Haskell Field

Town of Sudbury ADA Transition Plan

January 2021

Institute for Human Centered Design

Figure 1: View of Haskell Field showing the approximate location of accessible routes (yellow lines) and the approximate suggested location for new accessible routes (purple lines) that connect existing paths to all of the boundaries of sport activity and to park amenities.

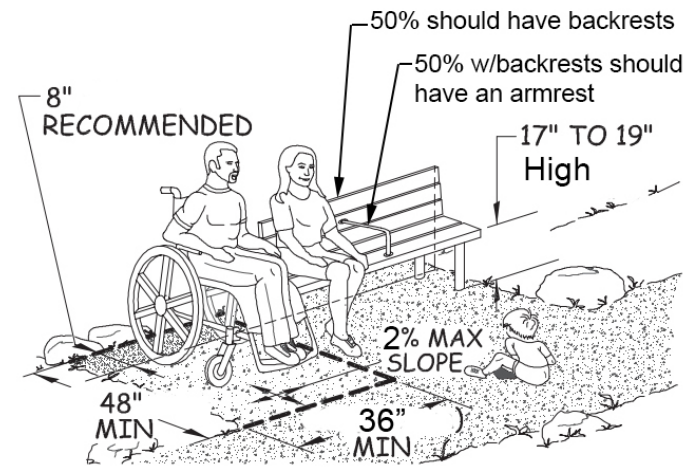
Accessibility issues include lack of accessible routes connecting existing pathways to all of the boundaries of sport activity including at multiple soccer fields, the baseball field and batting cage, team seating at the baseball field dugouts, and at sideline bleacher seating. Additional amenities not connected to an accessible route include benches, trash receptacles, picnic tables, a wayside and a bag dispenser for dog waste. Additional problems with the existing exterior access routes include excessive changes in level, excessive running and cross slopes, and a book exchange box at the concession stand that is a protruding object. (See Figure 1 and the end of this report narrative for more information about current and missing accessible routes at Haskell Field.)
